ATTACHMENT D

MARKED UP PAGES OF UFSAR

ATTACHMENT E

RESPONSE TO REQUEST FOR ADDITIONAL INFORMATION

FIG. 4-3. Comparison of Housner design response spectra and response spectrum for El Centro earthquake, 5/18/40 N-S component (Source: Refs. 7 and 10).

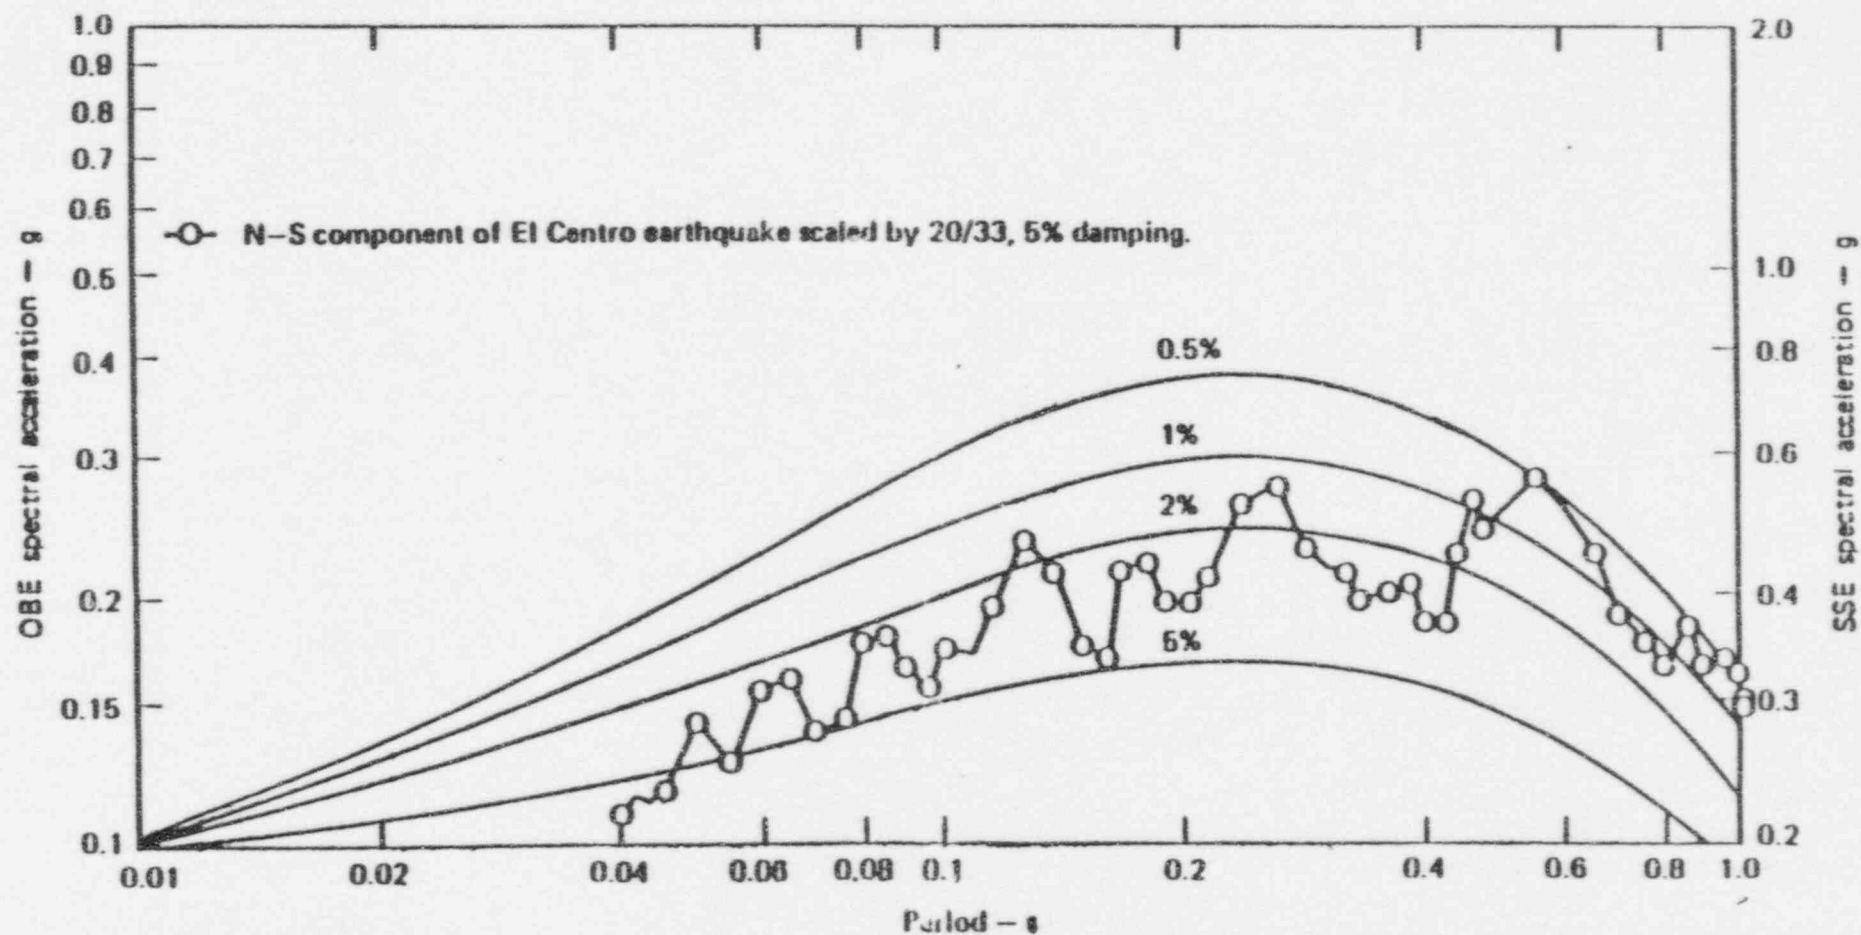
- 2.1 The use of Regulatory Guide 1.61 damping with original design spectra and analysis procedures is not permitted. Either the FSAR damping should be used or the design spectra and analysis methods for use with current damping should be upgraded. (Section 3.1)

The use of Regulatory Guide 1.61 damping with the design spectra for operability evaluations was authorized by the NRC during the IEB 79-14 program as well as during the evaluation of the Reactor Recirculation pump snubbers in 1986 (see documentation attached).

The attached letter from R.F. Janacek (CECo) to J.G. Keppler (NRC) on January 5, 1981 [6], explains the background to the use of Regulatory Guide 1.61 damping. For the purposes of this discussion, there are additional references to support the use of R.G. 1.61 damping:

- c. As noted in NUREG/CR-0891, "Seismic Review of Dresden Nuclear Power Station - Unit 2, For The Systematic Evaluation Program," [7] there was considerable margin between the response spectrum from the El Centro time history and the Housner design response spectrum (see Figure 4-3, attached) for periods above about .05 sec. The time history was used in the analysis of the reactor-turbine building.

Determine the functional status of the connection B4L.

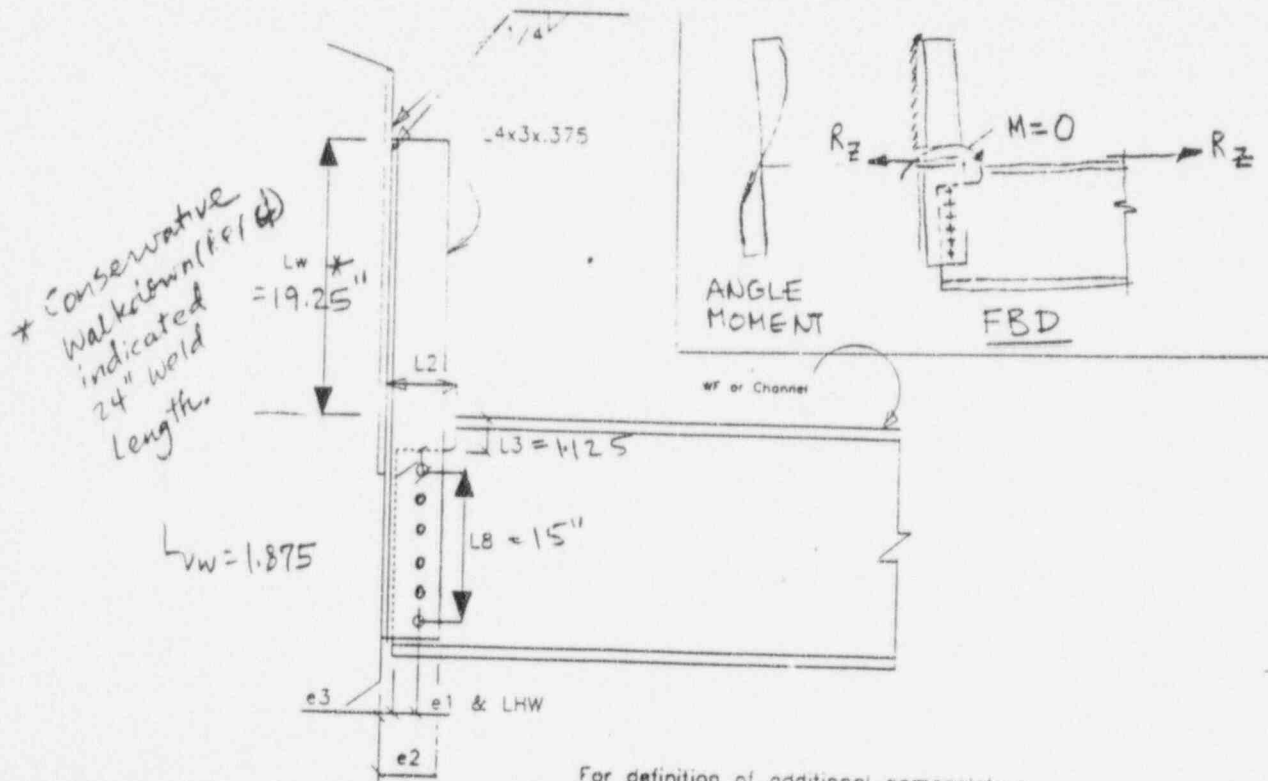
Provide information regarding the plates in connections 1R, 4L, 11R, and 33R that required the use of the operability strain criterion of 10 times the yield strain.

Since the Heat Exchanger tank is supported by the the top flange of beam B4, the following free body diagram is used to show that the point of zero moment in the connection angles is at a cross section taken at the top of beam flange. This model indicates that the critical section for angle bending will be at or below the top bolt hole, depending upon the distribution of the reaction in the bolts. The sections above the zero shear section are not critical because the angle, at these locations, is welded to 3/4" embed plate, and the composite section between the embed plate and the angles has significantly higher section properties than the angles alone.
